1986 CROSTOWN WATERLINE - SEWER

Re: Crosstown Waterline

CHANGE ORDER
NUMBER ONE

SUMMARY SHEET
CROSSTOWN WATERLINE REVISION

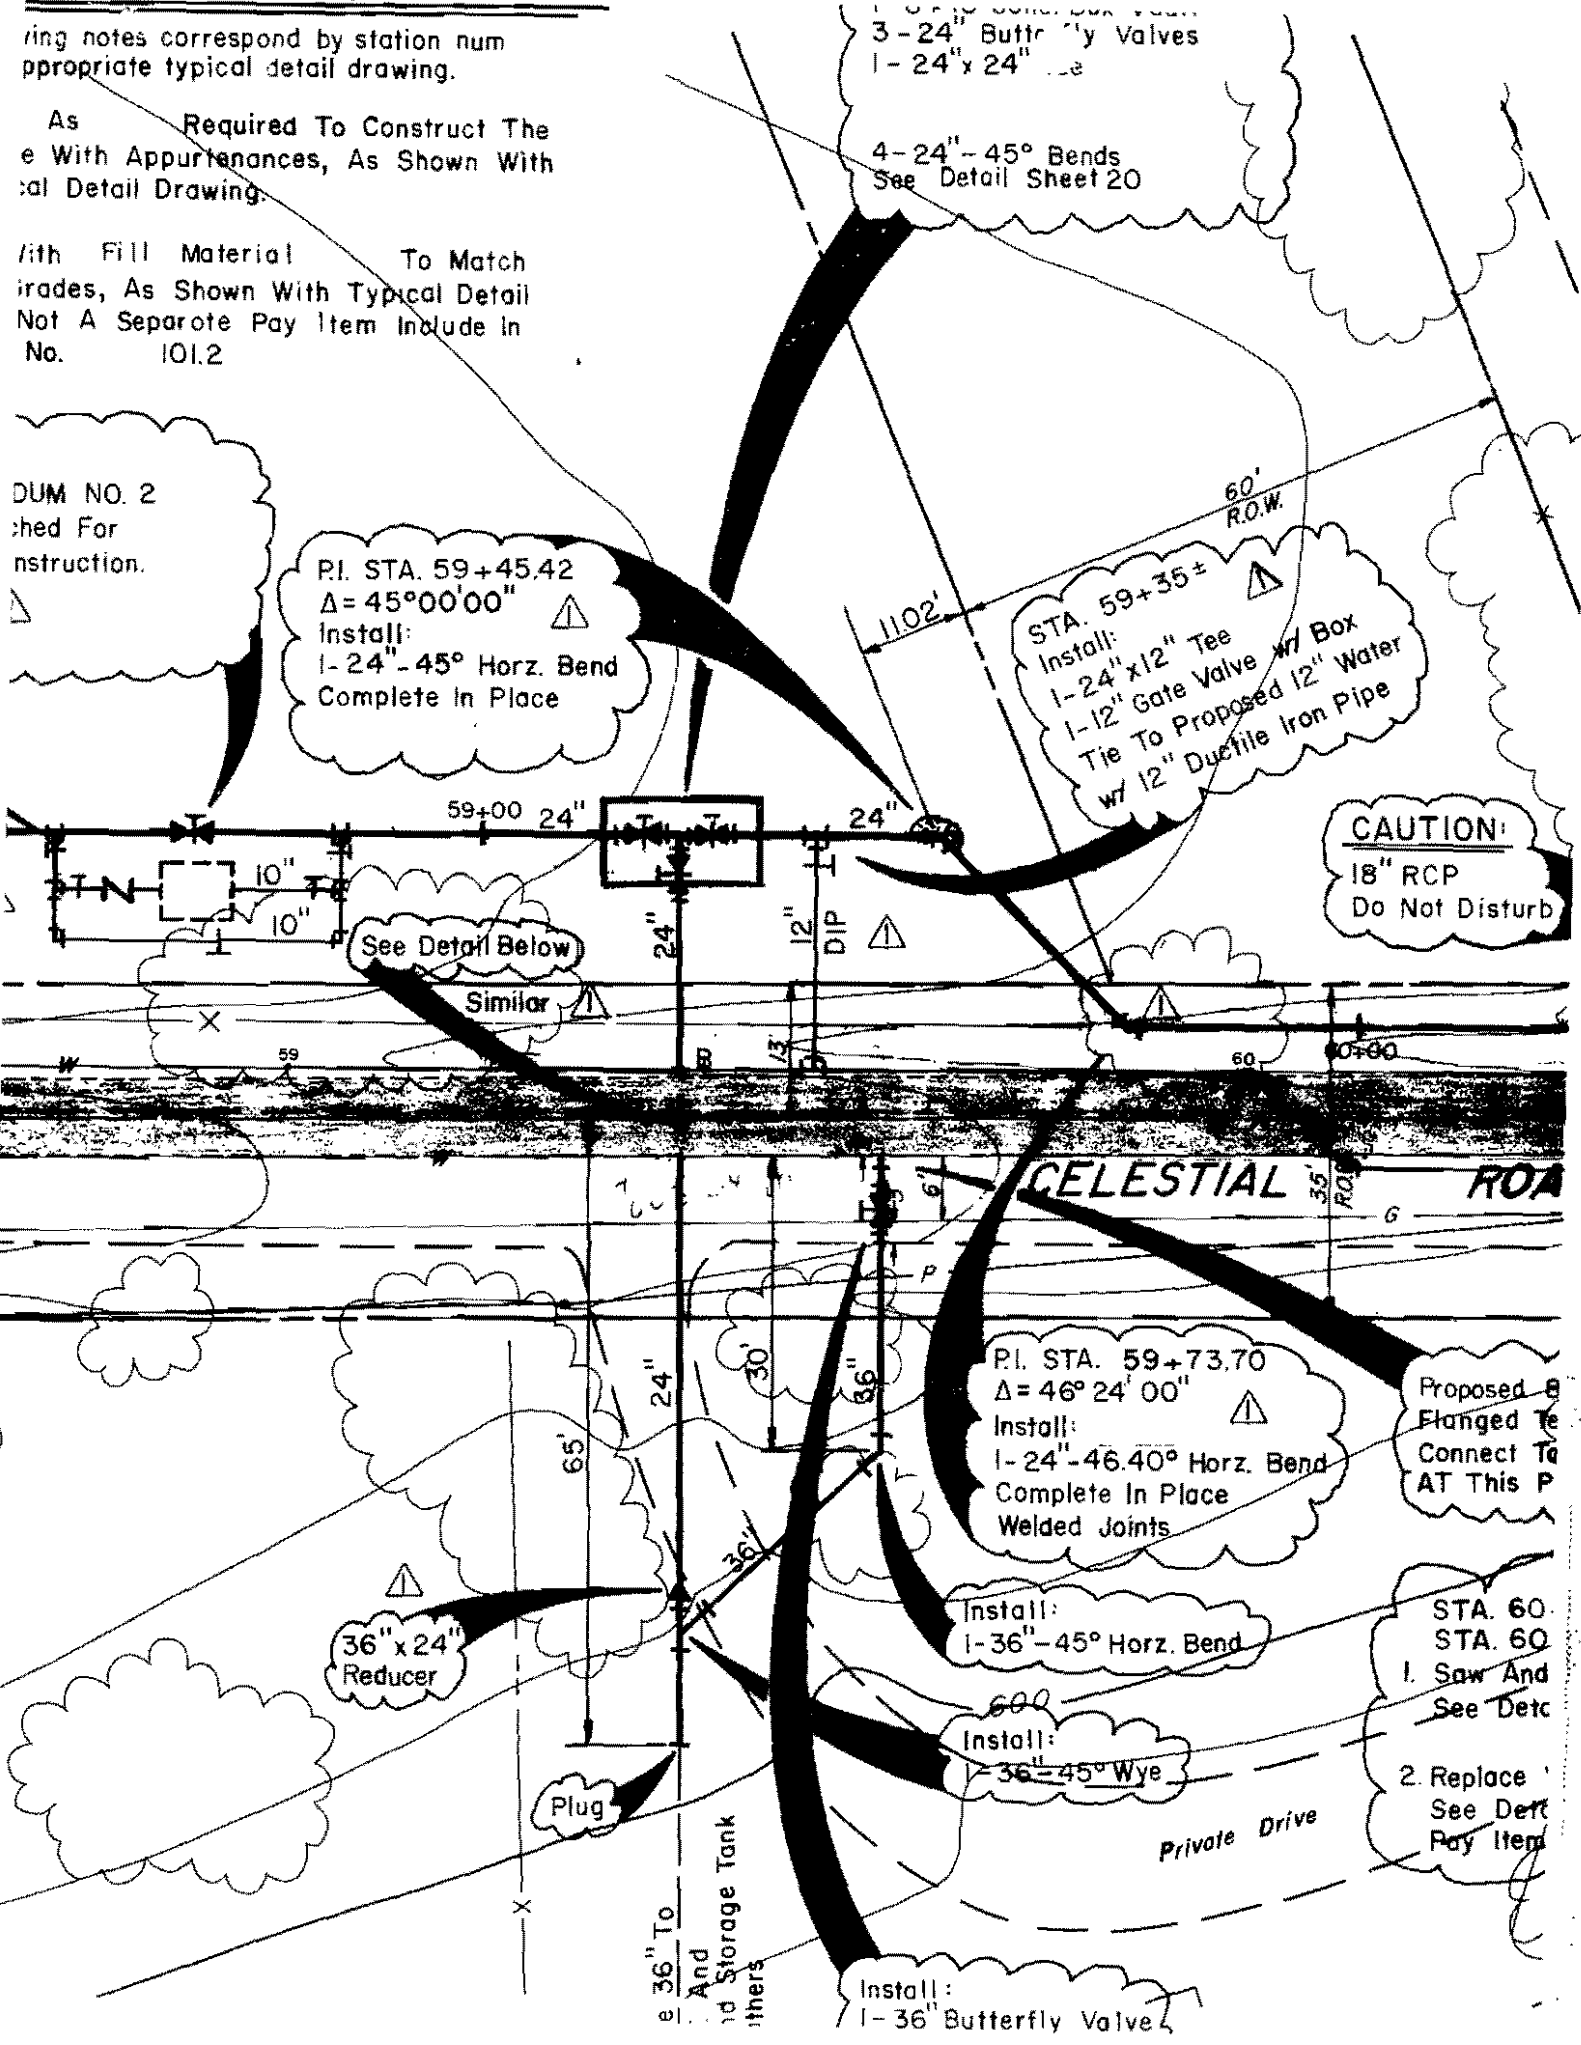
4- 24" - 45° Bends
See Detail Sheet 20

Install:
1- 36" - 45° Wye

2. Replace
See Detc
Pay Item

▲ REVISED 1-31-85
 ADDENDUM NO. 2
 DECEMBER 10, 1984
 GINN, INC. - CONSULTING ENGINEERS

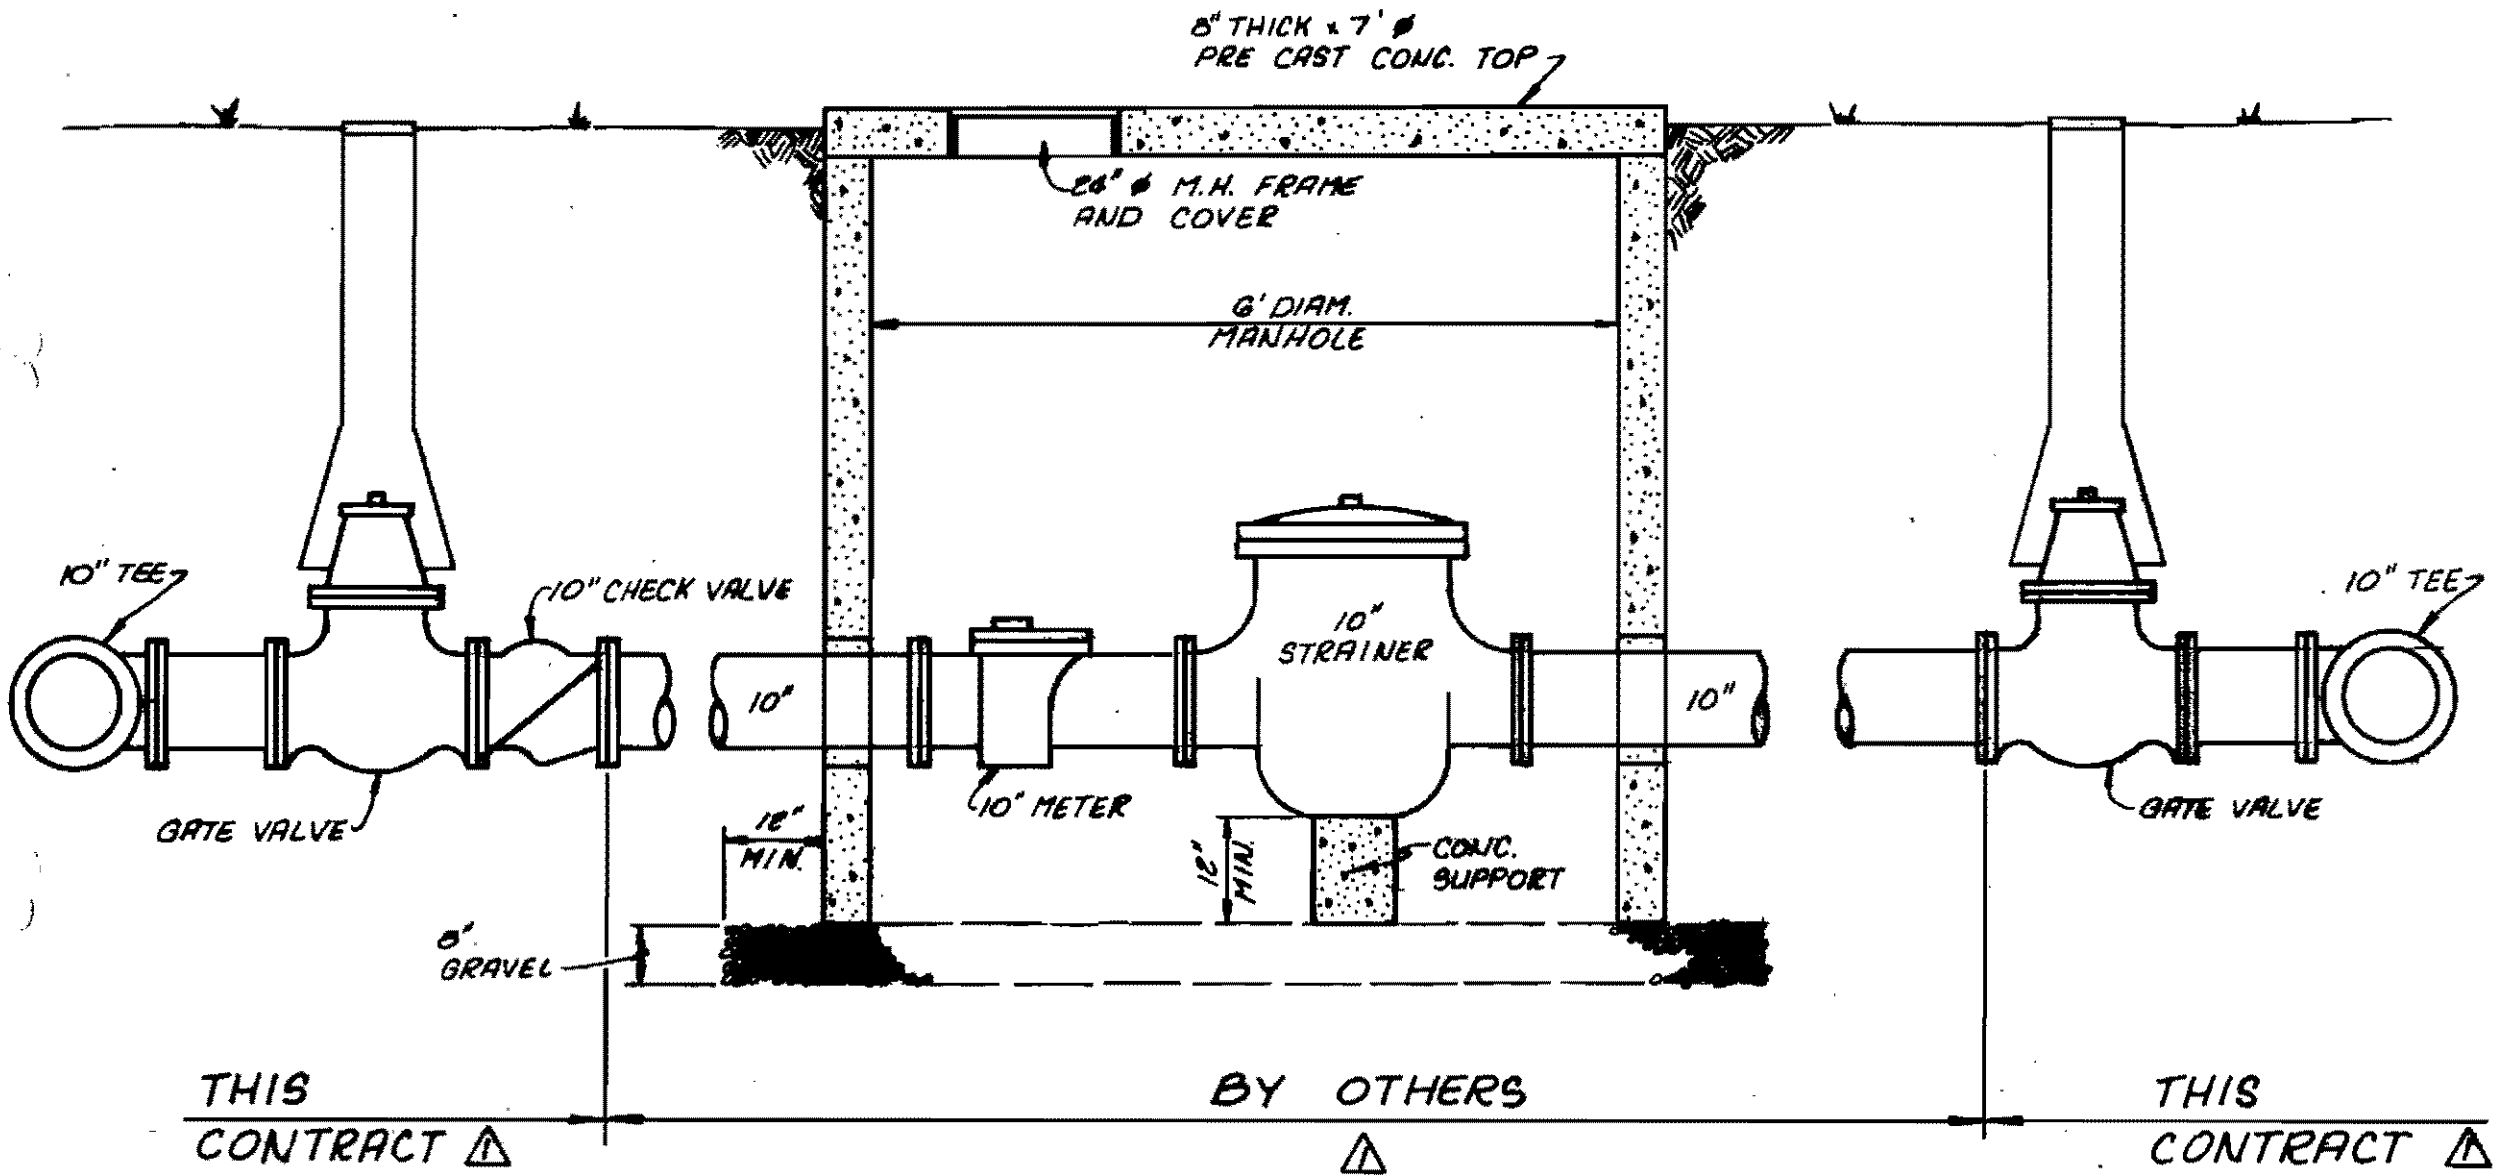
5. In profile, change 378 LF of 36" RCCP quantity to 141 LF 36" RCCP and 237 LF of 24" RCCP. Change 231 LF of 27" RCCP to 231 LF of 24" RCCP.
6. At Station 58+70, refer to Addendum No. 2 drawing for clarification of this revision.

Pay Item 107.1 previously included all that is shown on Addendum No. 2 drawing. This proposed revision will delete the portion between the gate valve on the east and the check valve in the west. This will be done by others. Delete approximately 25 LF of 10" ductile iron pipe, precast manhole (or concrete vault), 10" turbine meter and strainer. All other items pertaining to the 10" line to the meter and the 10" by-pass shall remain unchanged.
